RESPONSE TO SUDS

Planning Application: Land North of Taylors Farm

Application Reference: UTT/25/2786/OP

Document Status: Formal Written Objection

Picture 1: Takeley Wastewater Sewage Discharge to Pincey Brook

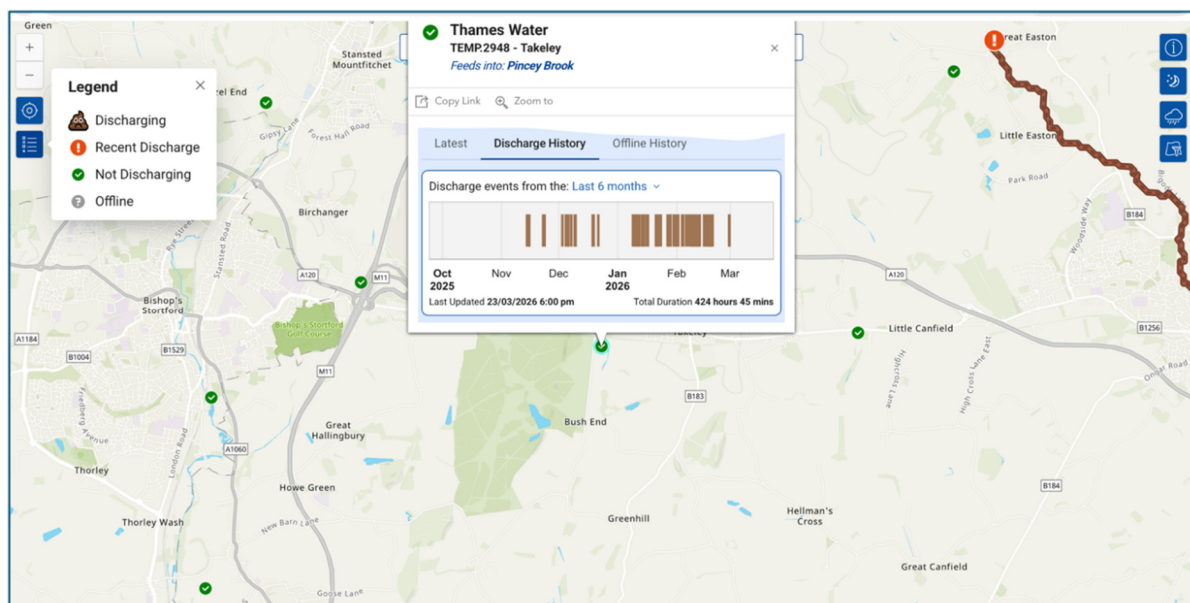
The Developer intends wastewater (both treated sewage and surface water) to go to Takeley Wastewater Treatment Works which does not have capacity and has discharged 424 hours of sewage directly to Pincey Brook between (Oct 2025-Mar 2026) (Picture 1).

Picture 2

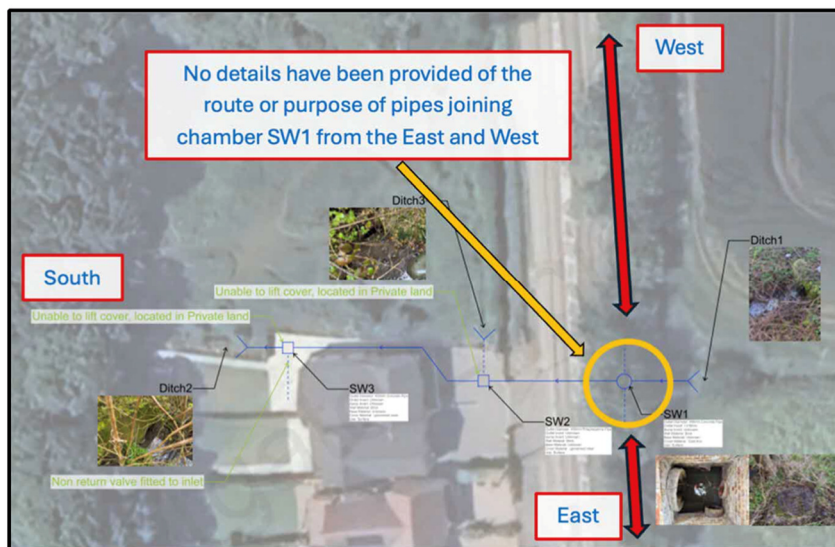
Extract from TSAG Dec 2025 comments detailing the SSFRA CCTV report which ignores specific details regarding the culverts East and West of the inspection Chamber indicated in the picture below. No further evidence has been supplied by the Developer.

Further investigation of the roadside ditch and Highway Drains connections are required.

Picture 3 Original diagram from South Uttlesford Site Development Templates

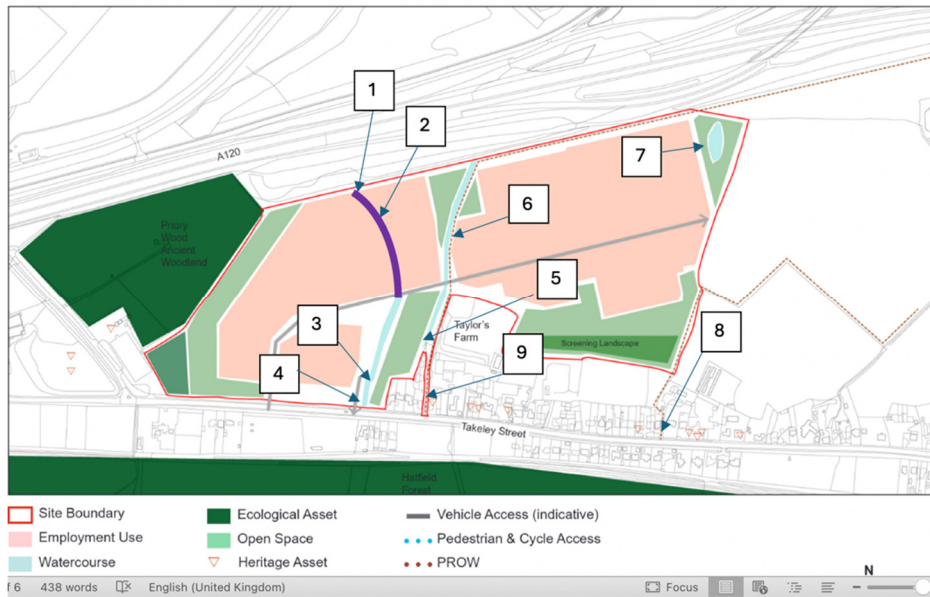
1. Inaccurate length of western watercourse. Actual length highlighted in purple.
2. Location of culvert outfall on western watercourse, arriving from north east angle. Length unknown, source unknown. Culvert diameter approximately 6 inches. Depth of brook approx. 6 foot. Evidence of old tress growing within brook to prove this is not a recently dug ditch.

3. Western watercourse culvert, approx. 5m in length presumably to allow tractors to cross. Modern, brick wall and concrete culvert.
4. Culvert from Western watercourse passing under B1256. Culvert diameter approximately 18 inches. Modern construction, brick wall surround.

5. Culvert from Eastern watercourse passing under B1256. Culvert diameter approximately 18 inches. Modern construction, brick wall surround. 2 additional culverts of modern plastic construction, unknown sources.

6. Eastern watercourse culvert, approx. 5m in length presumably to allow tractors to cross. Older style, made with timber.
7. Watercourse does not exist in the north-eastern boundary (although as this drawing is a future plan it may be part of their plans to have a pond here as the land does bank down in this section).

8. Depth of both watercourses approximately 6ft throughout.
